Re: Union Station Redevelopment – Public Comment

The Olvera Street Merchants have reviewed the Los Angeles Union Station Forecourt and Esplanade Improvement Project, Draft Environmental Impact Report – State Clearinghouse Number 2016121064.

Comments on EIR 2016121064: Los Angeles Union Station Forecourt and Esplanade Improvements Project
By: Munson Kwok, Sept. 25, 2017.

Figure 2: Proposed Bicycle Crossover at Arcadia Street

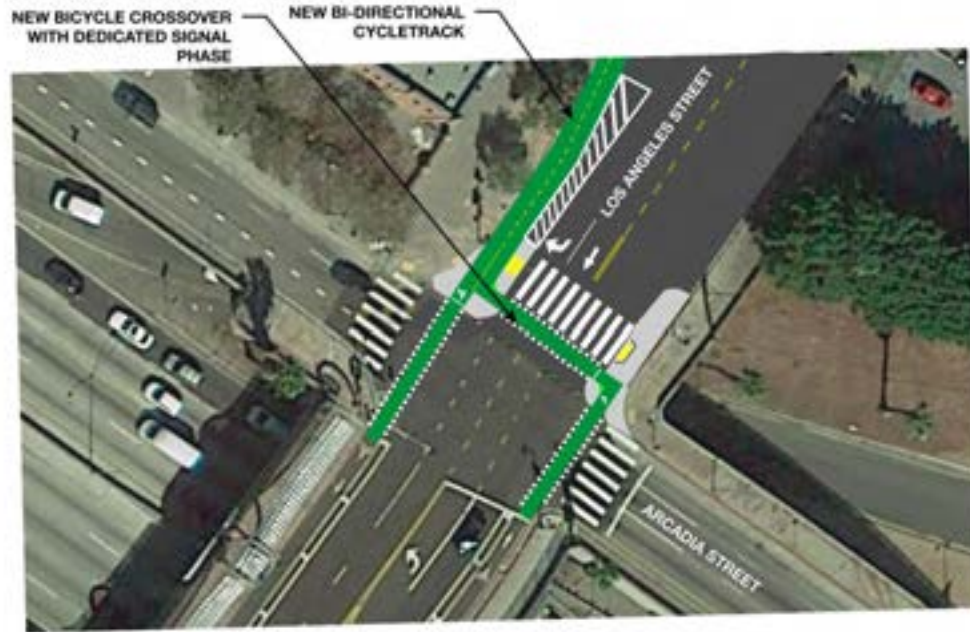
In order to provide continuous connection to Union Station from existing protected bike lanes on Los Angeles Street, such a plan should incorporate a crossover to accommodate northeast bound cyclists access to a two-way cycletrack on the North side of Los Angeles Street. Please see below diagram (Figure 2) showing a possible method to accommodate such a crossover.

I would urge the design team to fully 'walk' through the pathways that a person on a bike would need to take to access Union Station and the future Alameda Esplanade from existing bicycle infrastructure on Los Angeles Street. Currently provided alternatives result in conflicts that could be avoided by incorporating continuous bicycle infrastructure, without a gap in infrastructure at and approaching the intersection of Los Angeles Street and Alameda Street. Further, provided infrastructure for bicycle travel should accommodate direct pathways that direct people on bicycles through this corridor in an intuitive manner. I would further urge the design team to work with the Los Angeles County Bicycle Coalition and the City of Los Angeles Bicycle Advisory Committee to ensure a safe, accessible, and successful solution to accommodate travel by bicycle to and from Union Station.

This would provide a direct bicycle connection from the Alameda Esplanade via the raised bicycle crossing, to the southbound dedicated buffered bicycle lane for westbound bicycle users. This connection is represented diagrammatically in Figure 2.4-2, *Project Plan*, of the Draft EIR, with the bicycle crossing illustrated in green immediately south of the pedestrian crossing, and the southbound bicycle facility indicated in a light green band along the northern edge of Los Angeles Street. The comment inaccurately states that this facility would lead into the pedestrian plaza with no separation from pedestrian traffic.

Contingent on Caltrans approval, the existing unidirectional Los Angeles Street buffered bicycle lanes on either side of Los Angeles Street would be consolidated to provide two-way bicycle travel in an off-street bicycle path within the expanded El Pueblo plaza near the west side of Los Angeles Street. This facility would run north from the pedestrian crossing adjacent to El Pueblo, to the designated bicycle crossing across Alameda Street. The bicycle path would be designed to accommodate a landing area for passengers disembarking from tour buses in the designated tour bus parking zone in between the roadway and the bicycle path. A designated bicycle crossing from the east side to the west side of Los Angeles Street would be striped next to the pedestrian crosswalk across Los Angeles Street adjacent to El Pueblo, which would provide a connection for cyclists traveling northbound in the Los Angeles Street cycle track to be able to enter this two-way bicycle path and ultimately connect with Union Station.

While the ultimate design of the bicycle facility on Los Angeles Street will occur in the design phase of the project, to provide better clarity on the intended bicycle facility connections between the project and the Los Angeles Street bicycle facility, Figure 2.4-2 has been revised to provide more detailed illustrative example of how both northbound and southbound bicycle connections could be designed (see Chapter 9, *Clarifications and Revisions to the Draft EIR*). The commenter made a similar proposal for a cyclist crossing for northbound bicycles, but recommended that the crossing occur at Arcadia Street. That intersection is outside the project boundaries.
